STAFF REPORT
CITY OF BEVERLY HILLS

For the Design Review Commission
Meeting of March 3, 2011

SUBJECT: Required revisions to a previously approved R-1 Design Review Permit to allow a new two-story single-family residence located in the Central Area of the City, north of Santa Monica Boulevard at **601 North Crescent Drive.** (PL 101 0643)

Front Elevation – 2/3/2011

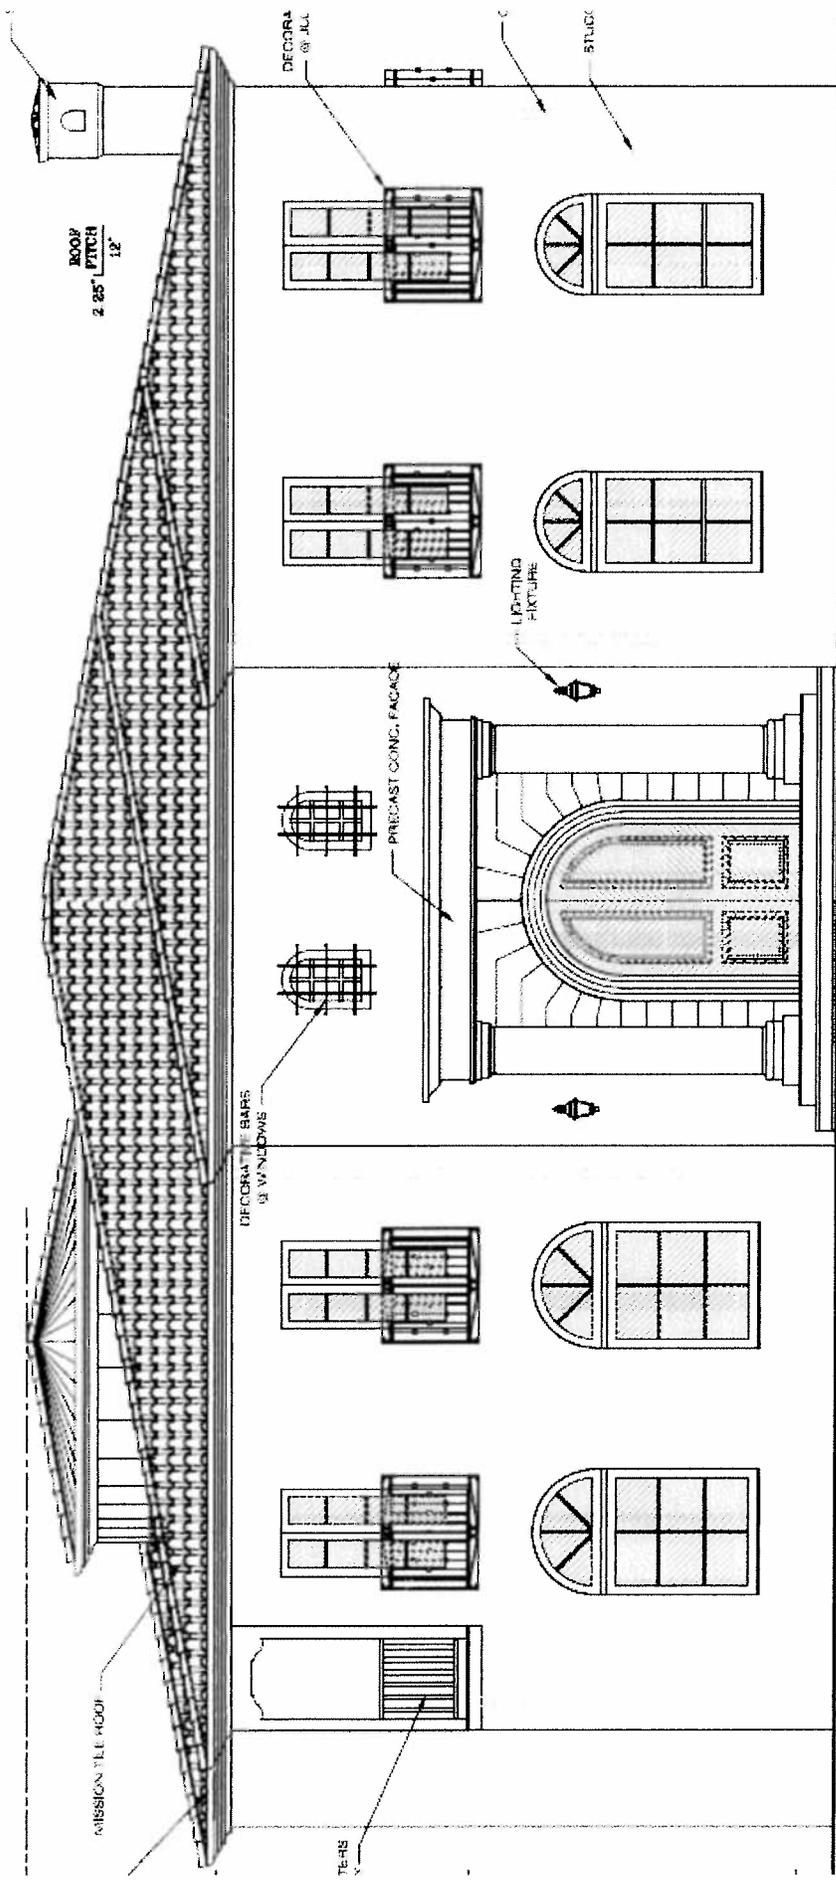
4. The ground floor windows on the northern portion of the front façade shall be redesigned to be the same size as the ground floor windows along the southern portion of the front façade.	4. The applicant has redesigned the windows as requested.

South Elevation – 2/3/2011

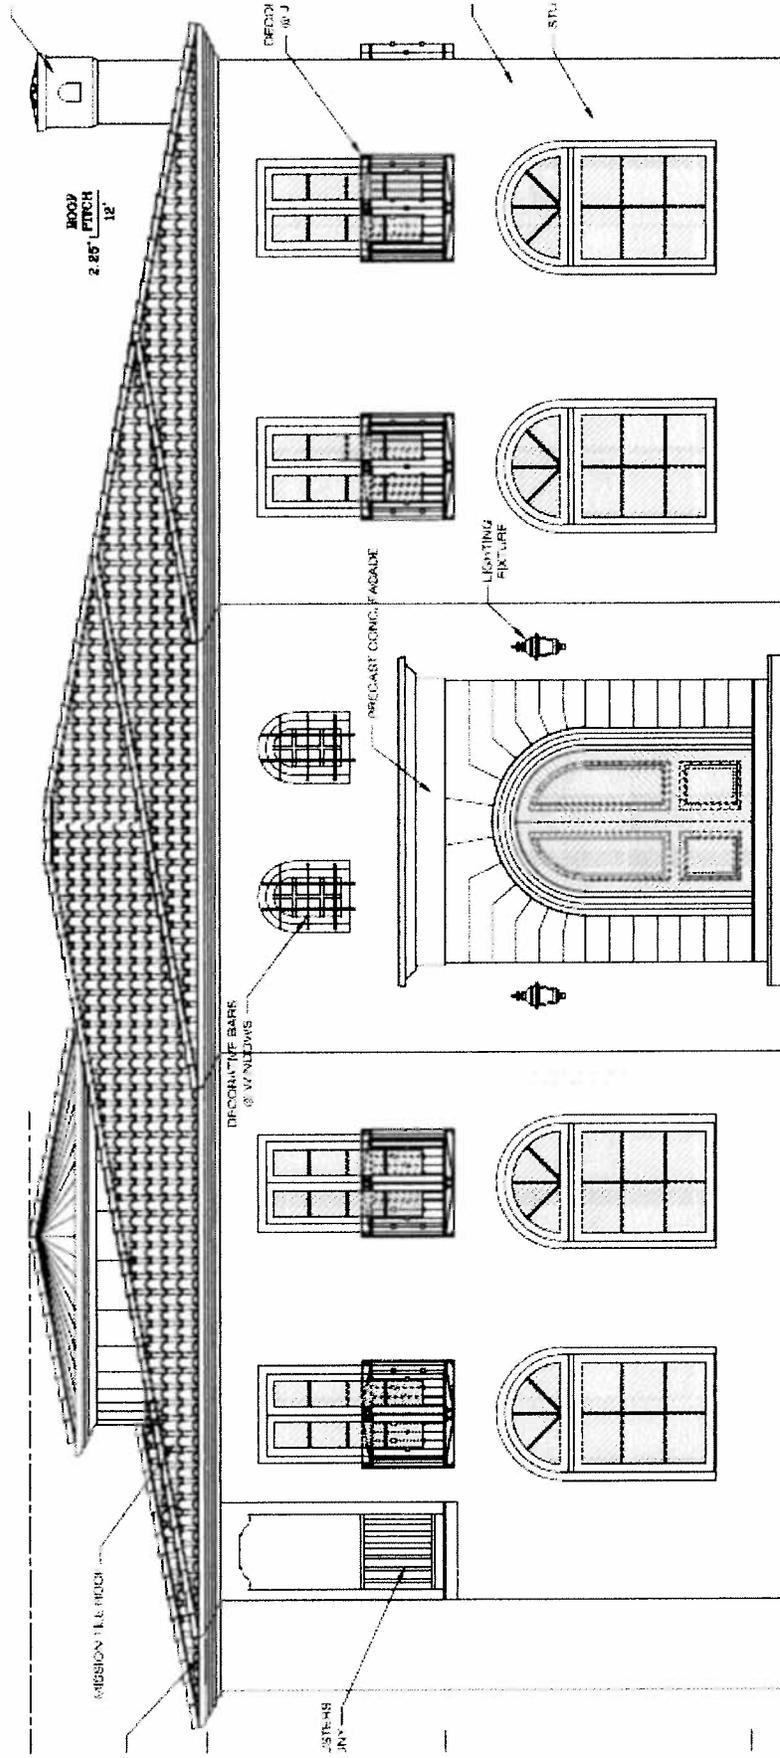
5. The windows shall be redesigned to have sills.	5. The window along the ground floor of both the front and street side façades have been redesigned to have window sills. The French doors along the second floor of both elevations have not been adjusted. See Sheet A3.01.

6. The window returns should be angled (flared), not straight.	6. The window returns along the ground floor of the front and street side facades have been redesigned to be angled (flared). See sheet A3.01.

Proposed South Elevation

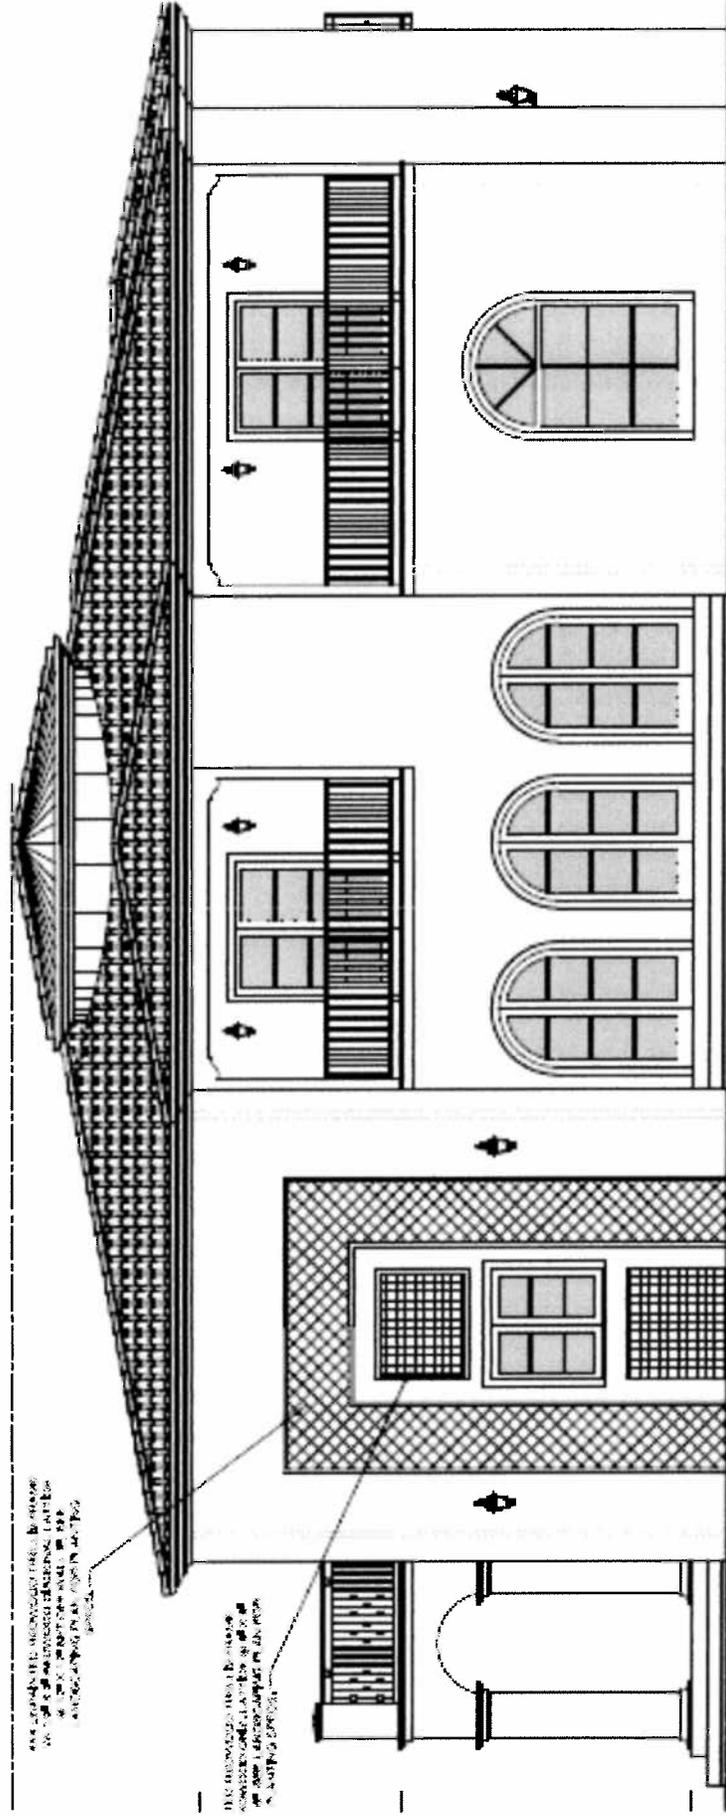
7. Mullions (similar to those on the windows on the front façade) shall be added to the ground floor window along the eastern portion of the southern façade.	7. The applicant has added mullions to the specified window.
